City of Alexandria, Virginia

MEMORANDUM

TO: URBAN DESIGN ADVISORY COMMITTEE (UDAC)

SUBJECT: 600 N. ROYAL STREET (WMATA BUS BARN SITE)

Attachment #1 – Proposed Building Height Variations and Transitions

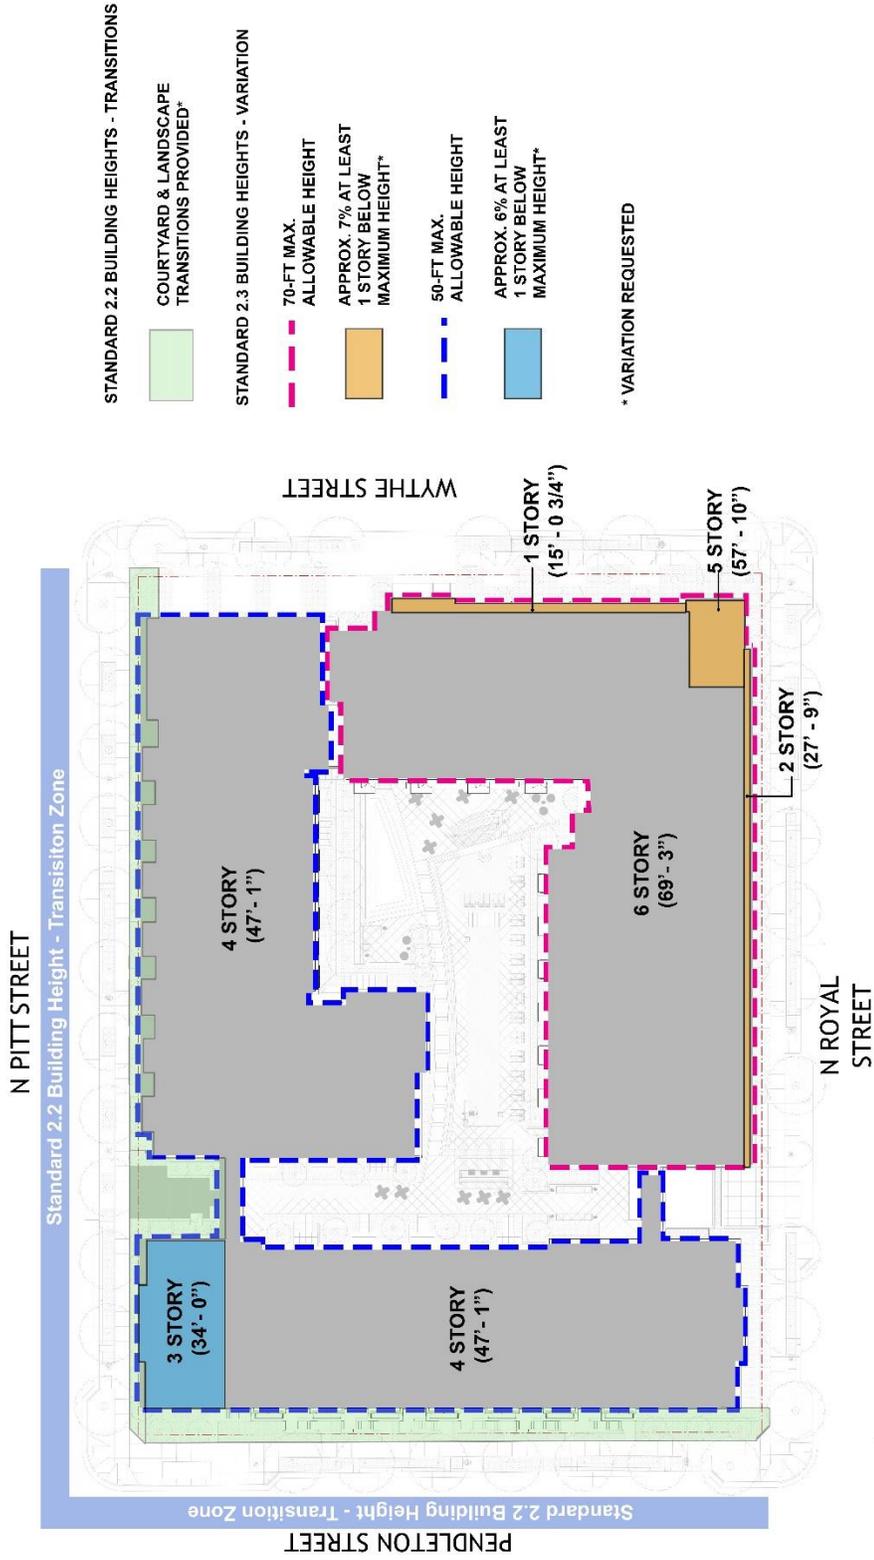
Staff Analysis: Figure 2.04 indicates that building height transitions are required on N. Pitt Street and Pendleton Street. The transitions proposed on these streets include a courtyard on N. Pitt Street and landscape buffers along both frontages. While the proposed transitions strive to meet the intent of this Standard, the extent of the height transition is limited on these specific blockfaces in comparison to the diagrams shown in Figure 2.05.

Staff Analysis: The applicant proposes variation in building height throughout the entire building (or block), rather than within the individual 50-foot portion and 70-foot portion of the building as the Standard implies. Variation from this standard is requested as the project is utilizing Section 7-

The attached diagram (Attachment #1) illustrates the variety of building heights as proposed and the areas of proposed building height transitions on N. Pitt Street and Pendleton Street. A memorandum prepared by the applicant is included with this submission which further demonstrates the proposal's compliance with each of the Urban Design Standards & Guidelines to assist in UDAC's review.

Staff finds that the applicant has responded positively to both Staff and UDAC's comments since the initial submission of the project in September 2018 and supports the variations as described above. Staff recommends UDAC's endorsement of this project for consideration by the Planning Commission and City Council in February 2019.
